GLOBAL SAFETY FIELD INVESTIGATIONS
DCS4069
URGENT - DISTRIBUTE IMMEDIATELY

Subject: 27620 - Customer Satisfaction Program
Incorrect Trailer Hitch

Models: 2015-2016 Chevrolet Colorado
2015-2016 GMC Canyon
Equipped with Heavy-Duty Trailering Package (RPO Z82)

27620 Incorrect Trailer Hitch

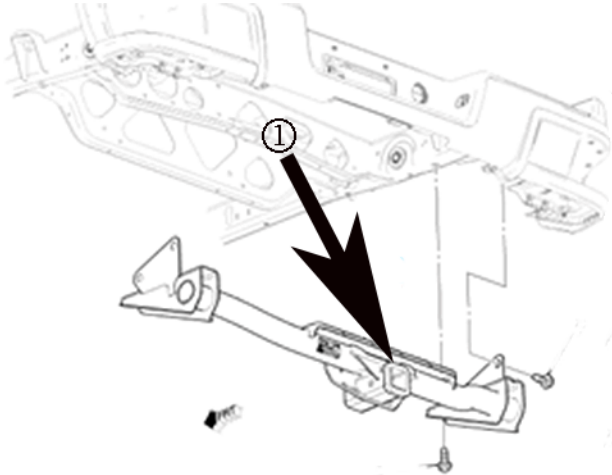
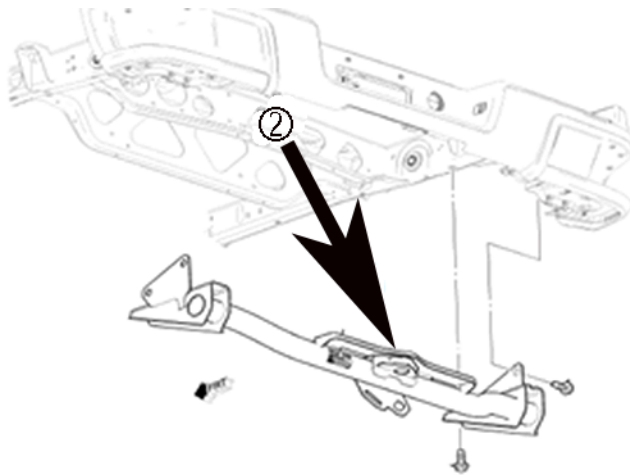
1. Verify the vehicle is equipped with the square receiver type hitch that hangs below the bumper (1). The incorrect non-receiver type hitch (2) is not visible from the outside of the vehicle, it is hidden by the bumper.

Correct receiver type hitch

Incorrect non-receiver type hitch

2. If the vehicle is equipped with the incorrect hitch (2), replace the hitch. Refer to *Trailer Hitch Platform Replacement* in SI.
